CONSTRUCTION CONTRACT CHANGE ORDER NUMBER: 3

CCSJ:	0921-02-321
Project:	STP 2021(256) MM
Highway:	Mile 3 N
County:	Hidalgo
District:	21-Pharr
Contract Number:	C-20-294-02-23

Change Order #3
Mile 3 N Road

Project: Mile 3 N Road
Project #: STP 2021 (256) MM
Contract: C-20-294-02-23
CSJ: 0921-02-321
Limits: Tom Gill Road to FM 492 (Goodwin Road)

STATE	COUNTY	CONTRACT NO.	SECTION NO.	POST MILE	SHEET NO.
TX	Hidalgo	0921	02	321	274a

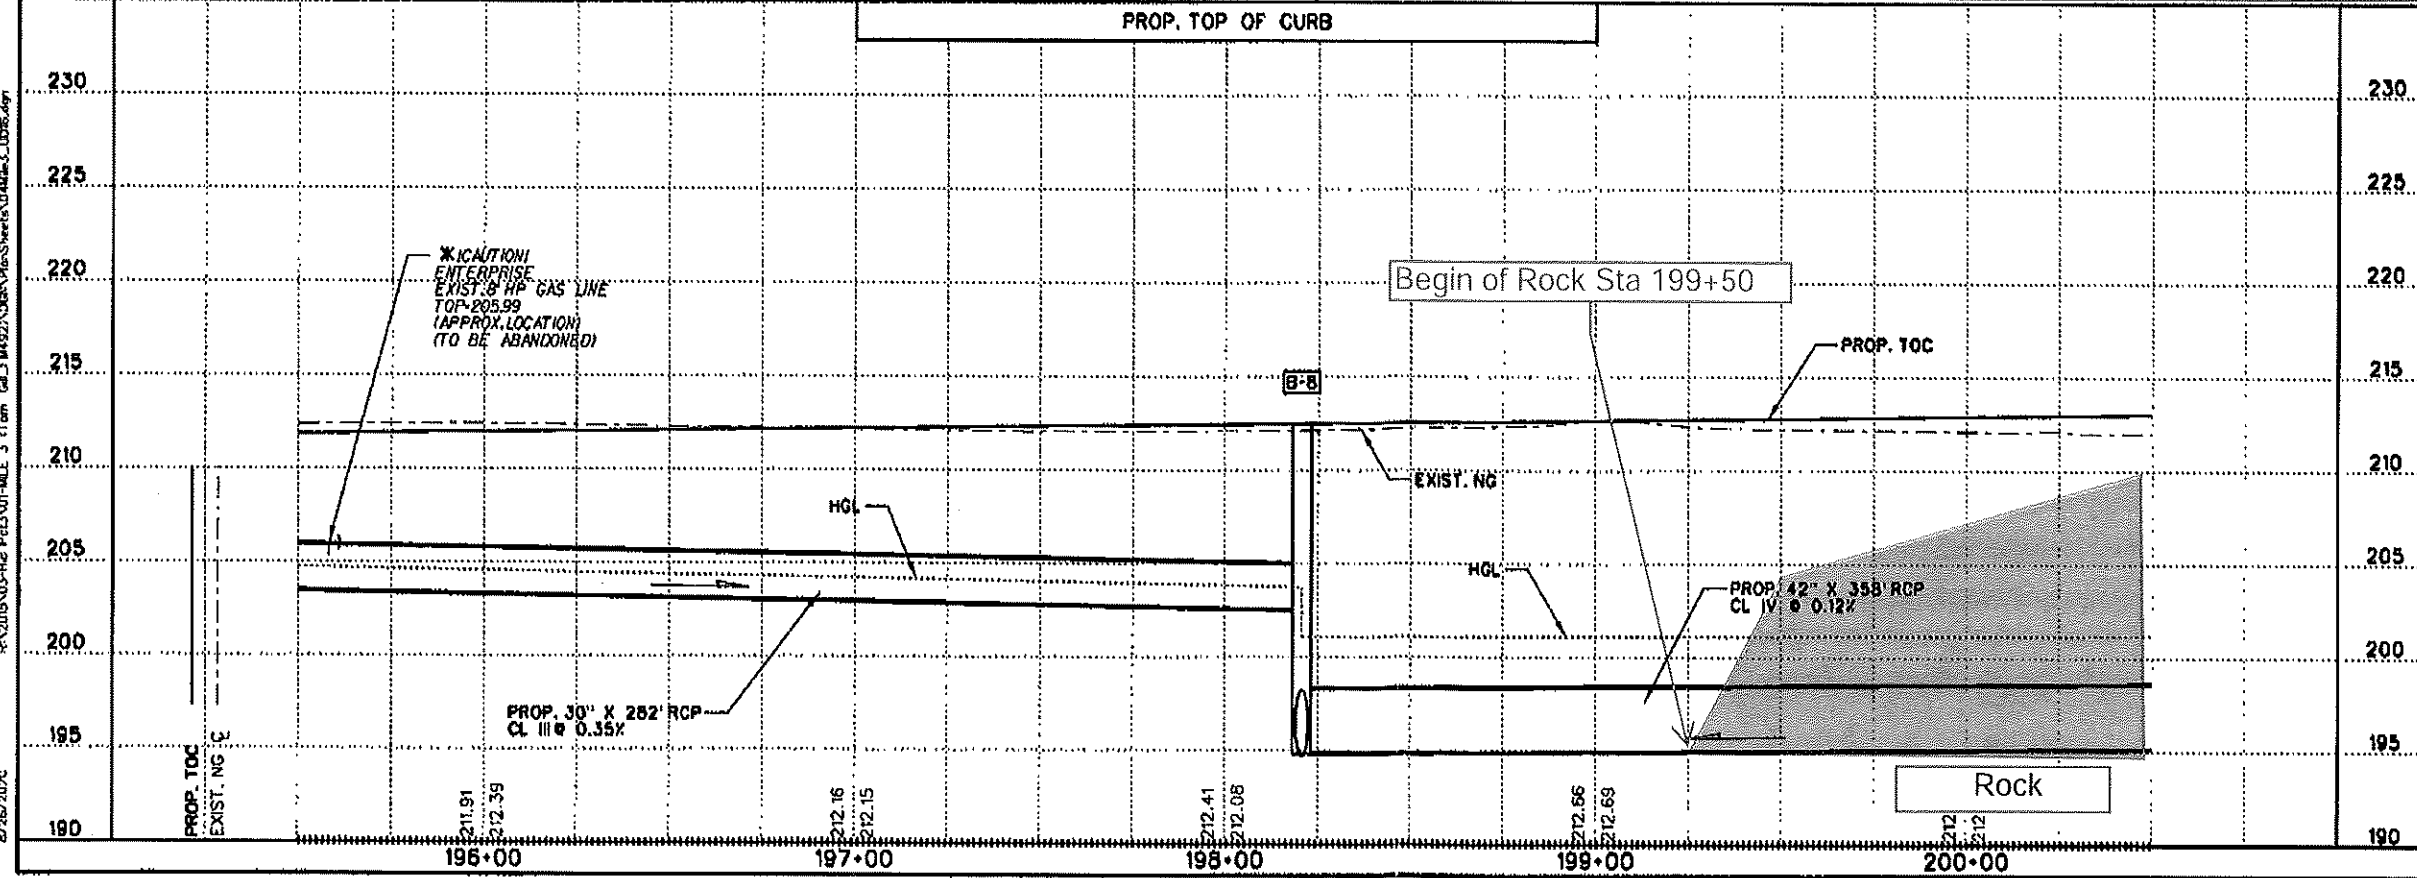
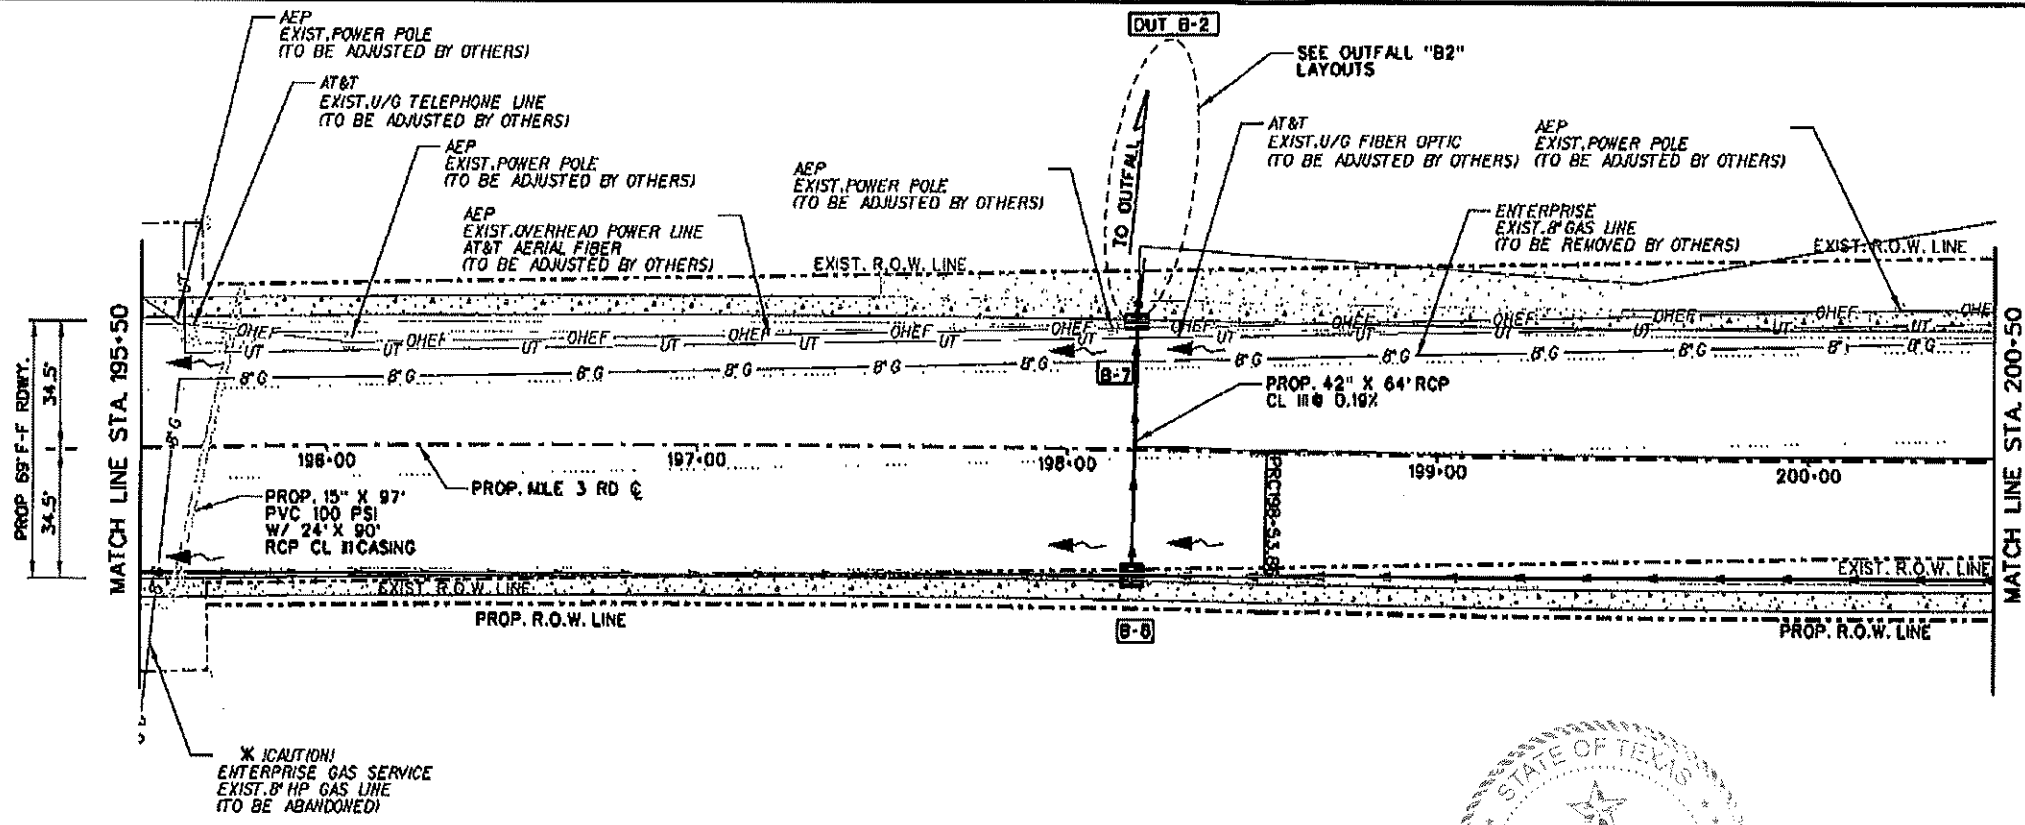
CO#3 - Change Order #3
Structural Excavation SPL
Rock Excavation and Removal

MILE 3 ROAD
 OUTFALL "B2" LAYOUT

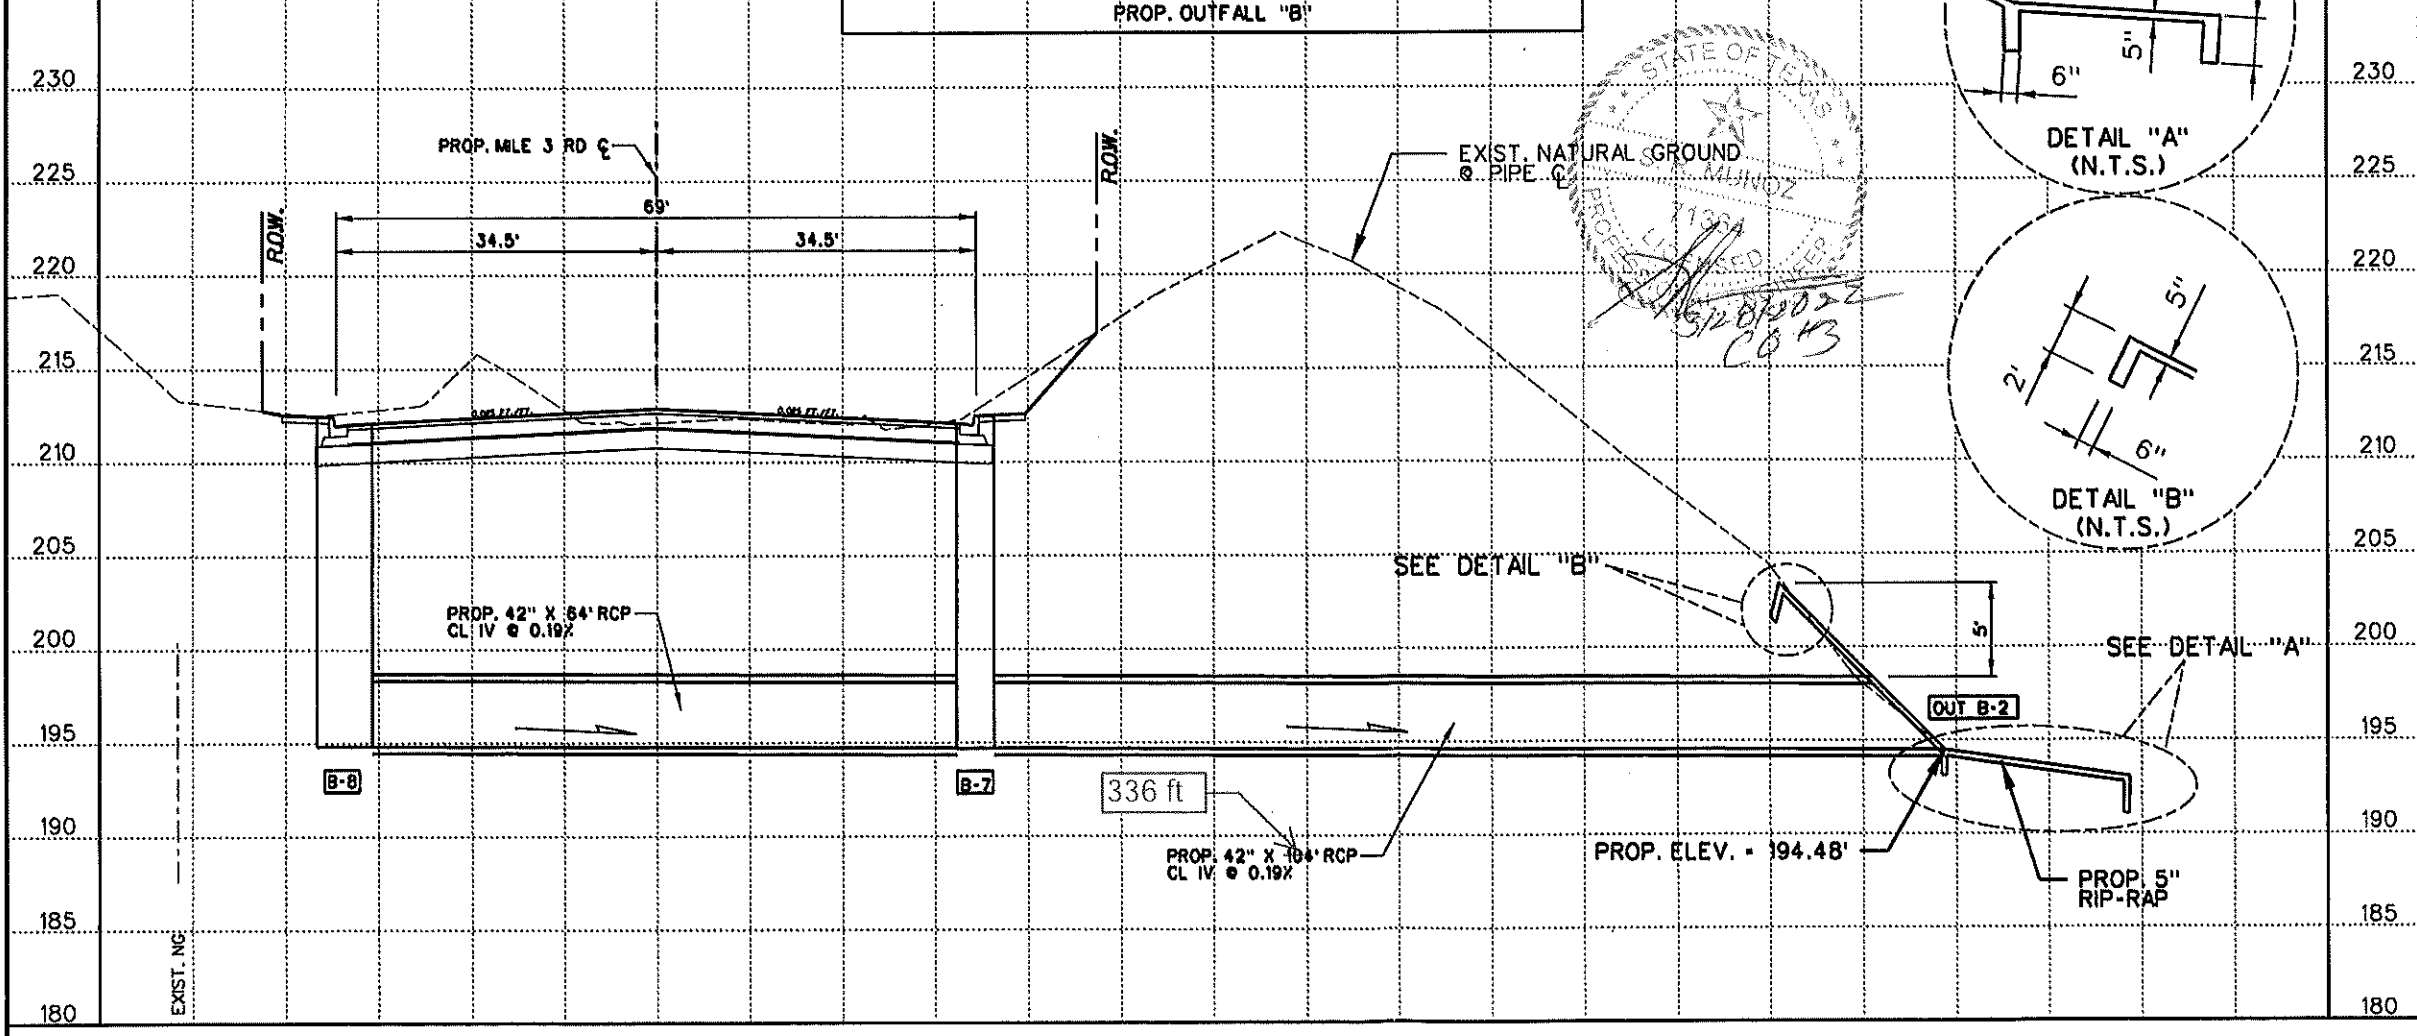
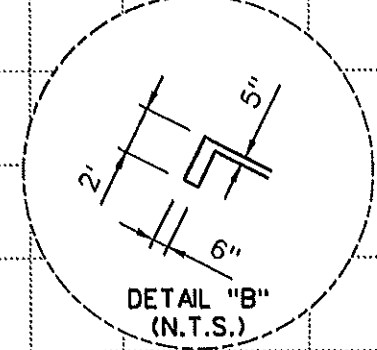
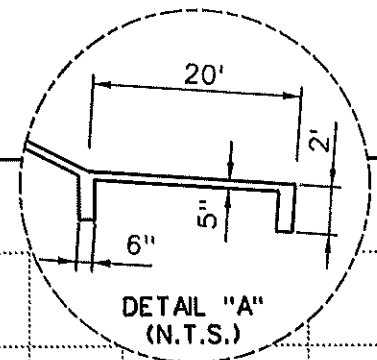
REIM encountered other differing site conditions when installing the reinforced concrete pipe in both Outfall's B & C. In Outfall B-2, REIM was instructed to add 232 ft of 42" CL IV to reach a

CO #3
Outfall B-2
Add 42 In Pipe
Plan Sheet 313a

MH B7 to OUTFALL "B-2"	104	Line Quantity
Actual	336	Revised Quantity
Added	232	of 42"RCP

CO#3 - Change Order #3
 1. Add to Structural Excavation SPL for Rock Excavation and Removal
 2. Increase 42" CL IV Pipe Quantity
 3. Decrease 54" CL III Pipe Quantity

Network "B" PQ	526
Revised Network "B" PQ	758

Item 42In RCP CL IV (PQ)	2102
Revised Item 42In RCP CL IV PQ	2334
